U.S. Department of the Interior BUREAU OF LAND MANAGEMENT

Well Name: POKER LAKE UNIT 15 Well Location: T24S / R31E / SEC 22 /

Sundry ID: 2745232

Type of Action: APD Change

WELL LOCATION AND ACREAGE DEDICATION PLAT

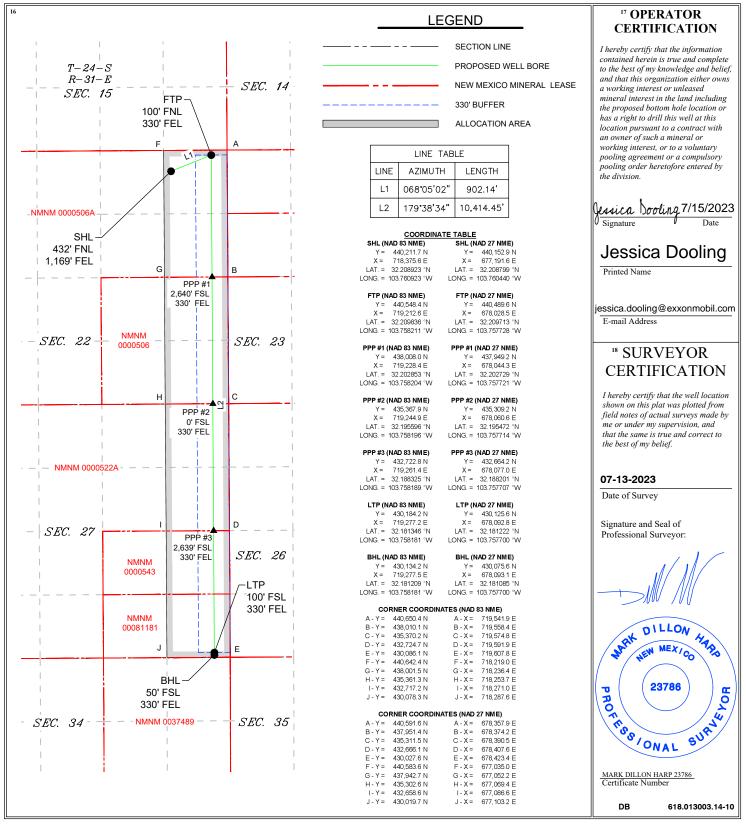
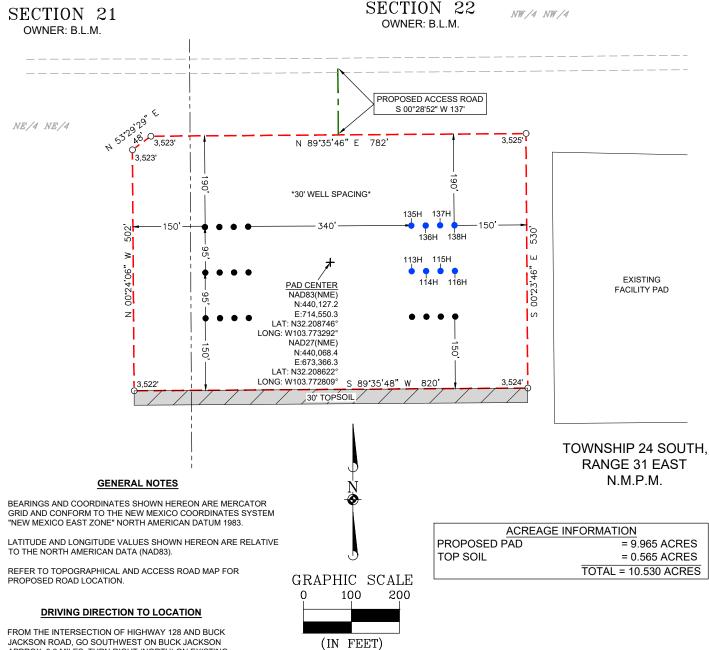
Procedure Description: ** Pool Change, First and Last Take Point Changes, Bottomhole Location Change, Drilling Plan Change, Casing/Cement Change, and Change Well Pad Names XTO Permian Operating, LCC. requests permission to make the following changes to the original APD: Change Pool from 96403 Wildcat; Bone Spring to 96546 Cotton Draw; Bone Spring South No Additional Surface Disturbance Change FTP: fr/330' FNL & 770' FEL to 100' FNL & 330' FEL, NMNM0506A PPP1 to 2640' FSL & 330' FEL, NMNM0506 PPP2 to 0' FSL & 330' FEL, NMNM0522A PPP3 to 2639' FSL & 330' FEL, NMNM0543 Change LTP: fr/330' FSL & 770' FEL to 100' FSL & 330' FSL, NMNM081181 Change BHL: fr/200'FSL & 770'FEL to 50'FSL & 330'FEL, Section 27-T24S-R31E NMNM081181 Change Name: Well Pad A to Well Pad F Change Name: Well Pad B/C to Well Pad G Change Name: Well Pad D to Well Pad H Casing/Cement design per the attached drilling program. Attachments: C102 Drilling Program Directional Plan Well Pad F WSL Well Pad G WSL Well Pad H WSL
